ATTACHMENT B

design review updates

number name	date	sent by
1912.01 Ketchum Prologue Hotel	21 0908	Ryan McMullen

Please see below responses in red concerning drawing updates to the Ketchum Prologue Hotel Design Review Submittal based on Order of Decision conditions in Section IV of the Findings of Fact, Conclusions of Law, and Order of Decision document date 02-05-2021, File No P19-063.

INDOOR DUCT WORK SOLUTION

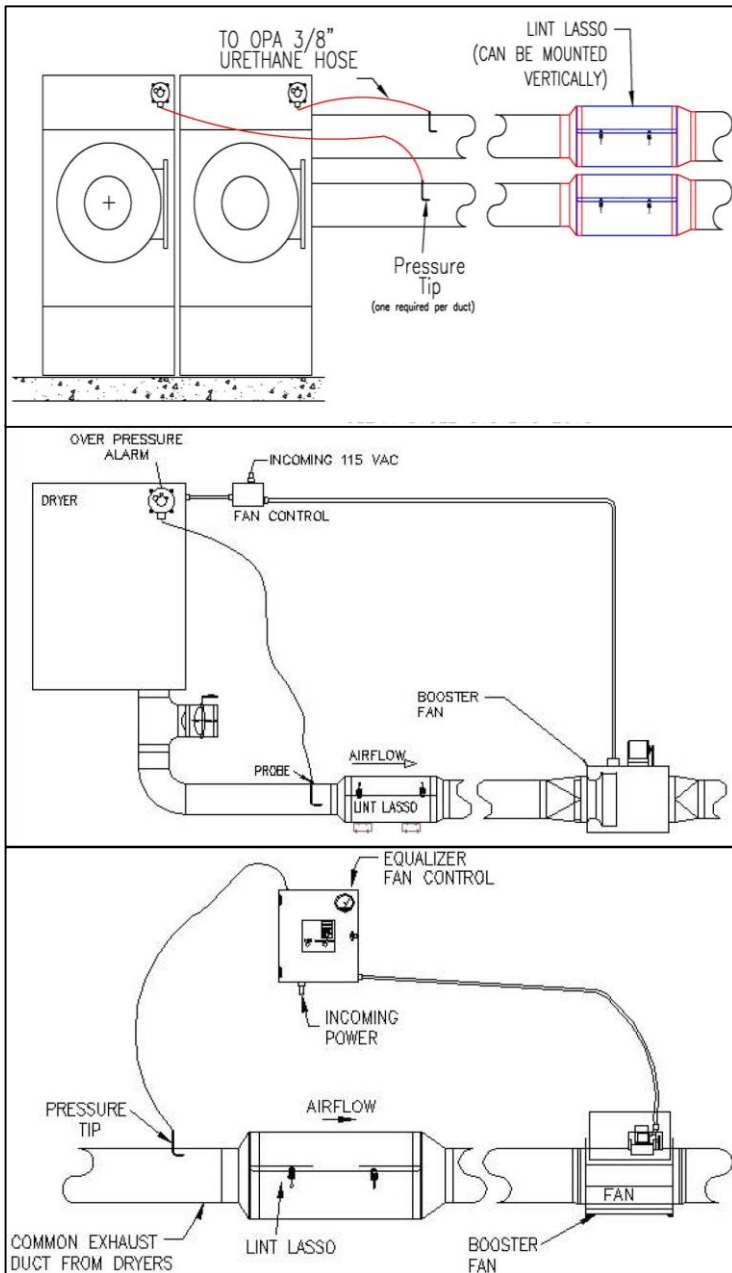
4. **Condition No. 21 – Design Review – West Property Utility Impact:** – At the time of Design Review the applicant shall be required to address venting of mechanicals that vent toward the western property line. Applicant shall be required to provide detail related to how they are preventing impact to the adjacent property owner.

Venting and exhaust along this property line will be minimized as a majority of the HVAC equipment for this project will be roof mounted or located on the opposite side of the building along SH75. Vents that are planned to occur along this property line include the commercial dryer ventilation. This commercial dryer ventilation system will feature a series of filters and lint traps that effectively catch lint adjacent to the dryers. In addition to the filters, the vents will be 17'-0" from adjacent property line, and the ducting will be designed with velocity that will not cross the property line. Attached product cut-sheet of the lint trap system provides additional information, and increased setbacks are reflected on all site and floor plans.
